PUBLIC SERVICE ELECTRIC & GAS COMPANY
ATLANTIC CITY ELECTRIC COMPANY
DOCKET NO. 50-354
HOPE CREEK GENERATING STATION
AMENDMENT TO FACILITY OPERATING LICENSE

Amendment No. 15
License No. NPF-57

Attachment:
Changes to the Technical
Specifications

ATTACHMENT TO LICENSE AMENDMENT NO. 15

Figure 3.2.1-1

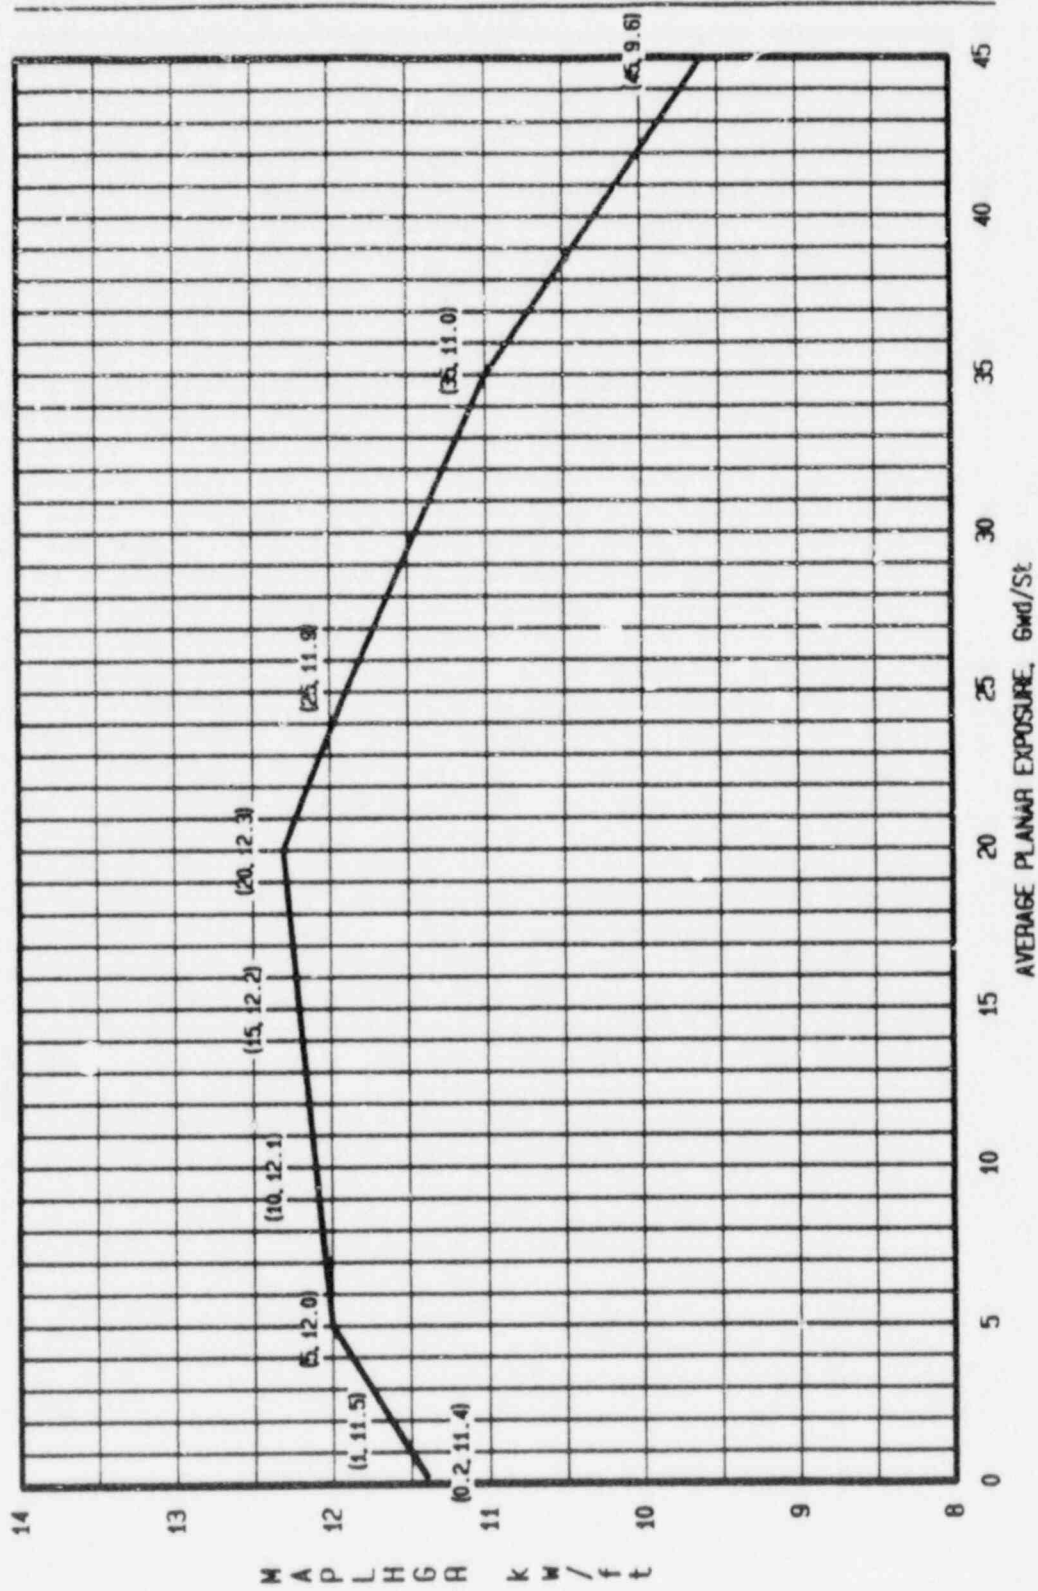
3.2.1 All AVERAGE PLANAR LINEAR HEAT GENERATION RATES (APLHGRs) for each type of fuel as a function of AVERAGE PLANAR EXPOSURE shall not exceed the limits shown in Figures 3.2.1-1, 3.2.1-2, 3.2.1-3, 3.2.1-4, and 3.2.1-5. The limits of Figures 3.2.1-1, 3.2.1-2, 3.2.1-3, 3.2.1-4 and 3.2.1-5 shall be reduced to a value of 0.86 times the two recirculation loop operation limit when in single recirculation loop operation.

Figure 3.2.3-1

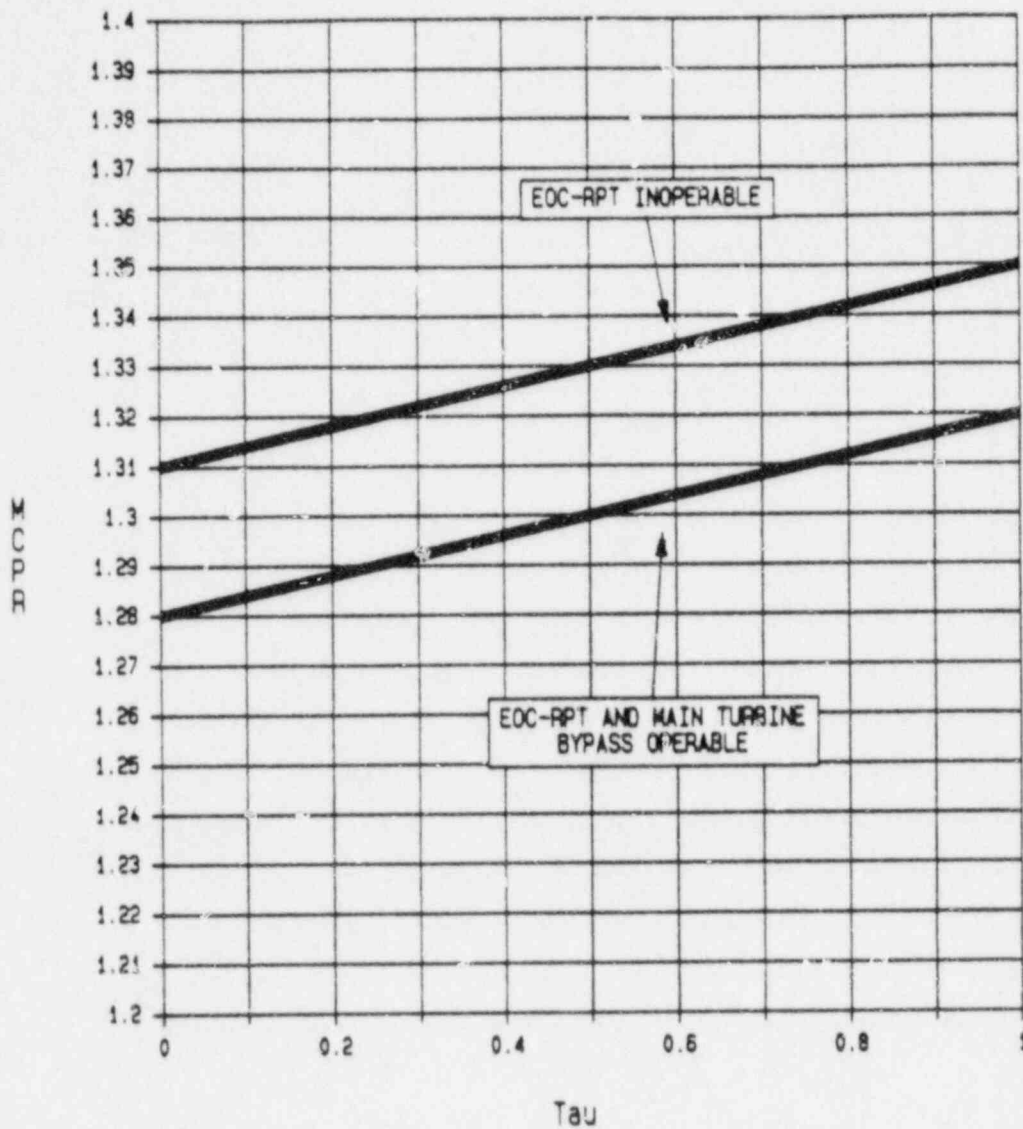
3.2.3 The MINIMUM CRITICAL POWER RATIO (MCPR) shall be equal to or greater than the MCPR limit shown in Figure 3.2.3-1 or Figure 3.2.3-2, as applicable, times the K_f shown in Figure 3.2.3-3, with:
